ORDINANCE NO. 2206-22

AN ORDINANCE GRANTING A SPECIAL USE PERMIT FOR A PLANNED UNIT DEVELOPMENT FOR AN EVENT VENUE AND GRANTING CERTAIN RELIEF FROM THE VILLAGE'S ZONING ORDINANCE — HH-HW-RE, LLC —INTERSECTION OF GILMER ROAD AND ILLINOIS ROUTE 176

- Comment Response Letter prepared by Pearson, Brown & Associates, Inc. dated October 25, 2022.

issue date: April 28, 2022  
 sheet name: THE BARN AT HAWTHORN WOODS LANDSCAPE PLAN  
 sheet number: L1

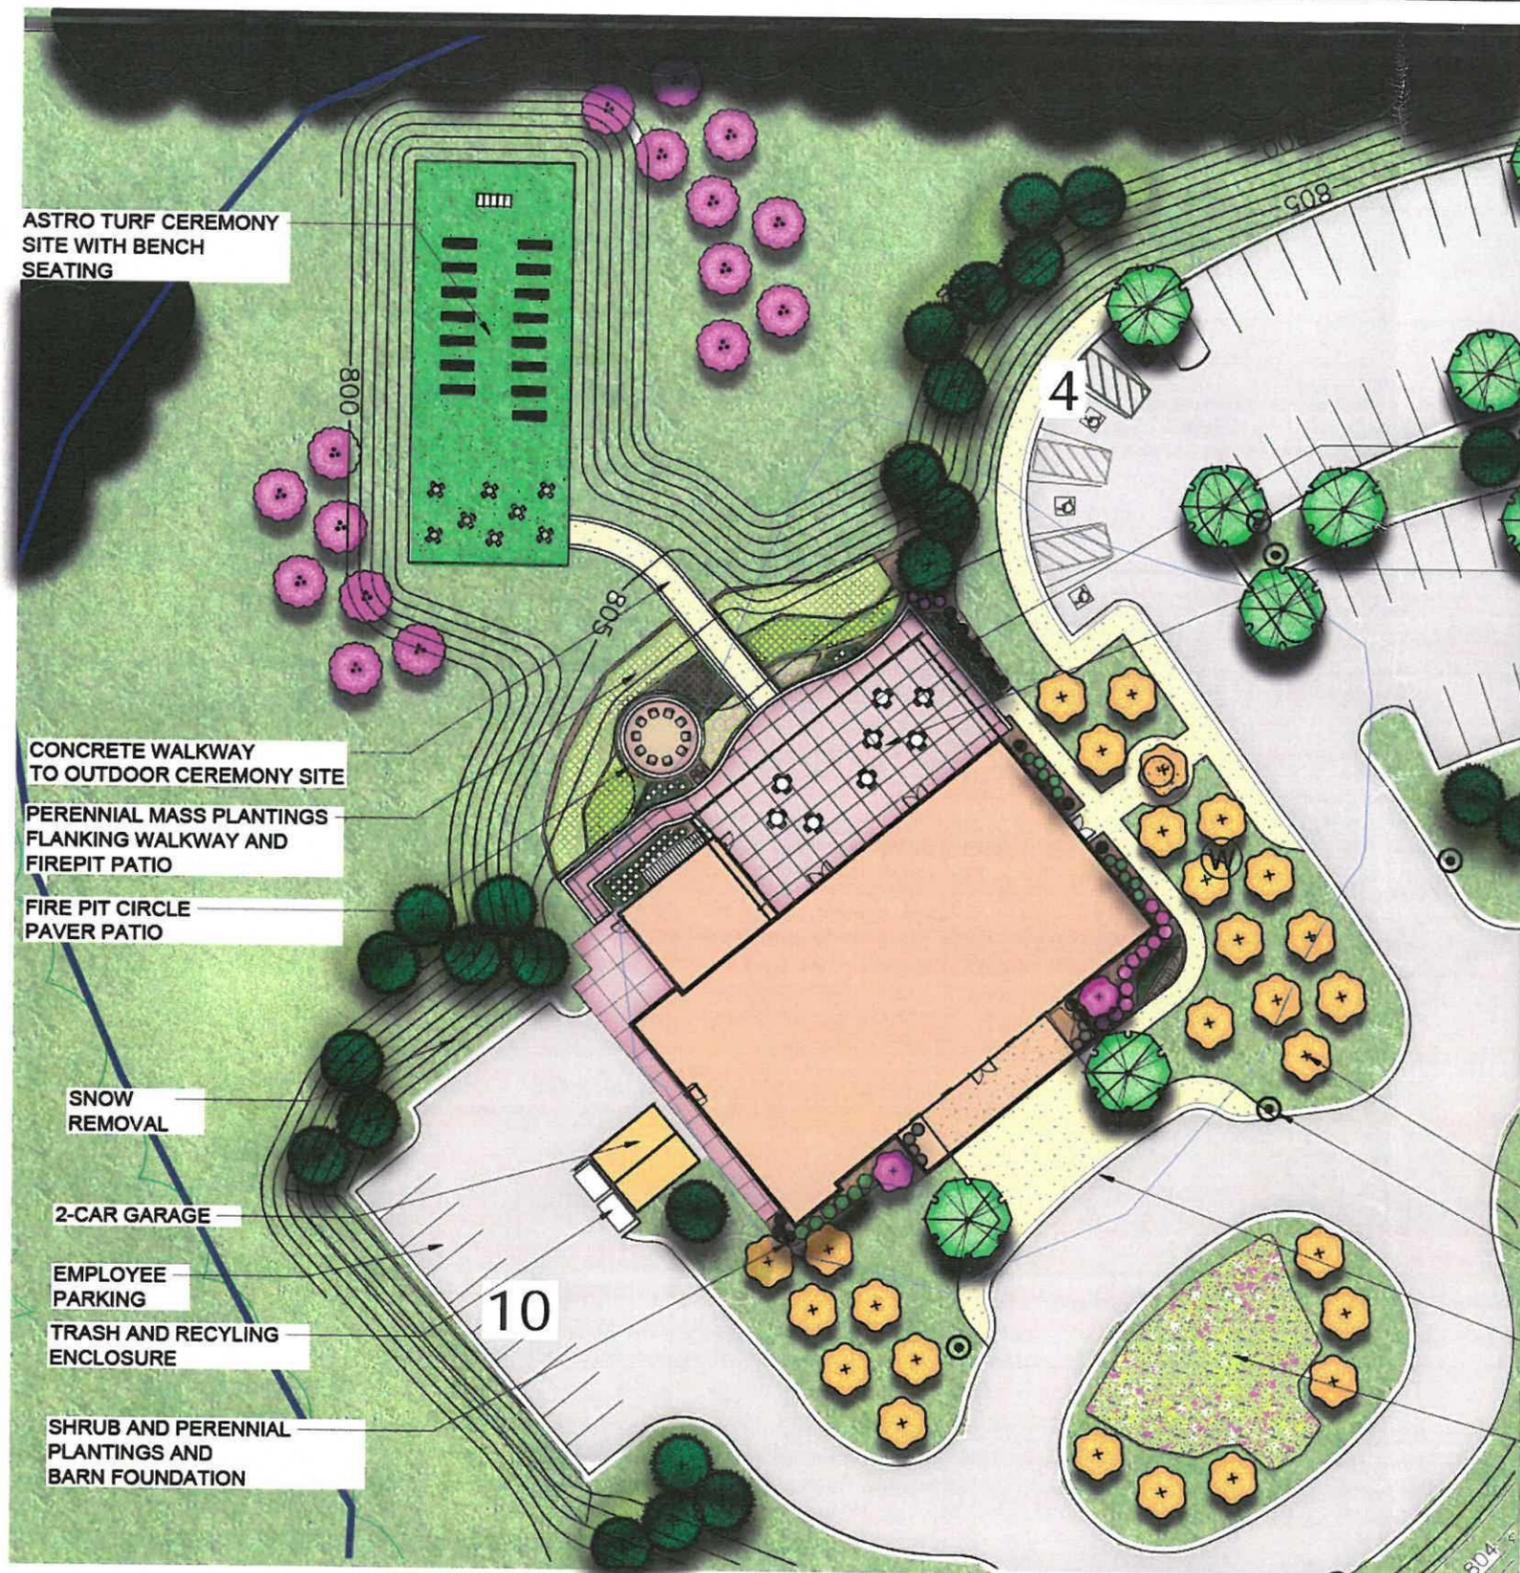
1. It appears that the Geometrics Plan from Pearson, Brown & Associates, dated May 4, 2022 and sheet SP3 from Teska Associates both differ from sheet L1 from Teska Associates. The parking lot areas shown in the Geometrics plan and sheet SP3 appear to not have the landscape islands shown on the plan. The L1 plan shows the correct parking lot islands at a rate of 1 parking lot island per 100' or less.
